Docket No. 50-336
B18111

Millstone Nuclear Power Station, Unit No. 2
Core Operating Limits Report - Cycle 14, Revision 0

Core Operating Limits Report - Cycle 14, Revision 0

FIGURE 2.5-1
AXIAL SHAPE INDEX vs.
PERCENT OF ALLOWABLE POWER LEVEL

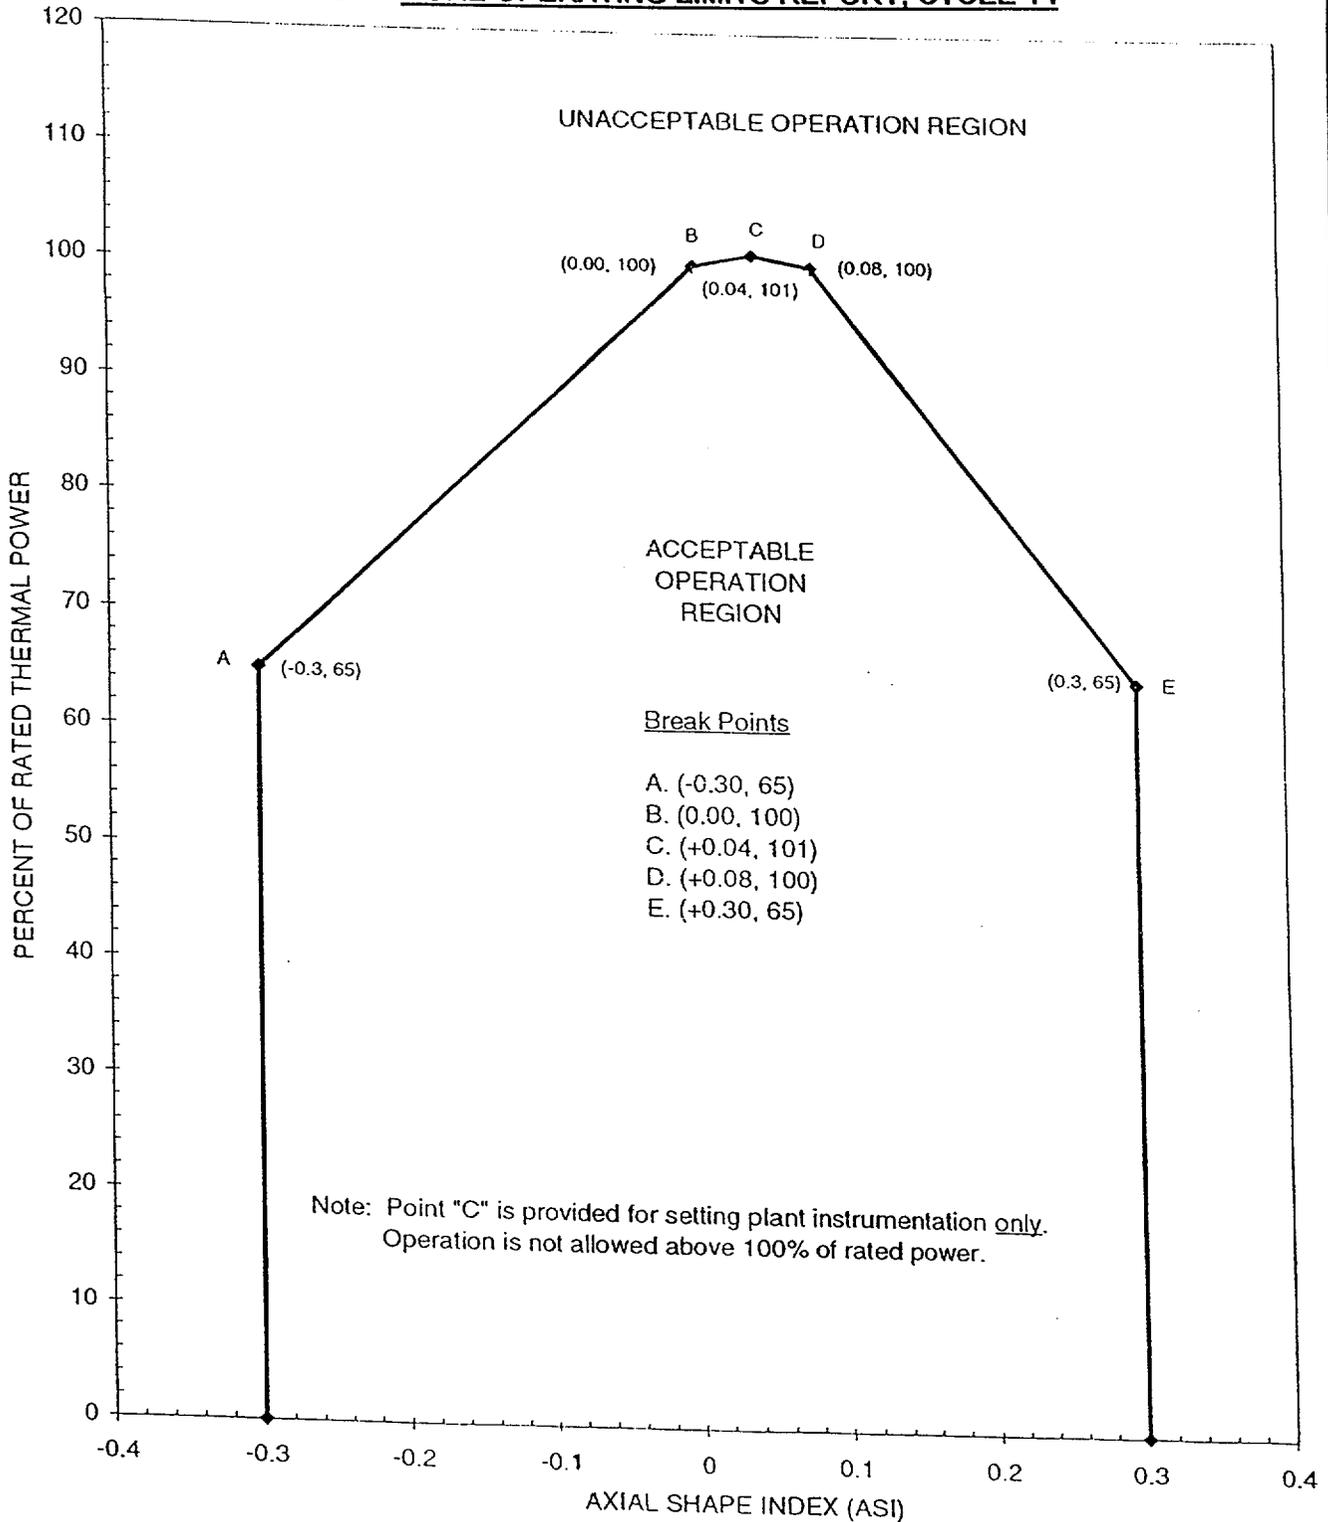
- a. 100% power limit for Total Unrodded Integrated Radial Peaking Factor (F_r^T) will be increased from 1.67 to 1.69 (this change also effects the power dependent F_r^T limit curve, Figure 2.6-1).
- b. The excore detector linear heat rate limits shall be restored to the original Cycle 13 limits (Figure 2.5-1).

During operation with the linear heat rate being monitored by the Excore Detector Monitoring System, the AXIAL SHAPE INDEX shall remain within the limits of Figure 2.5-1.
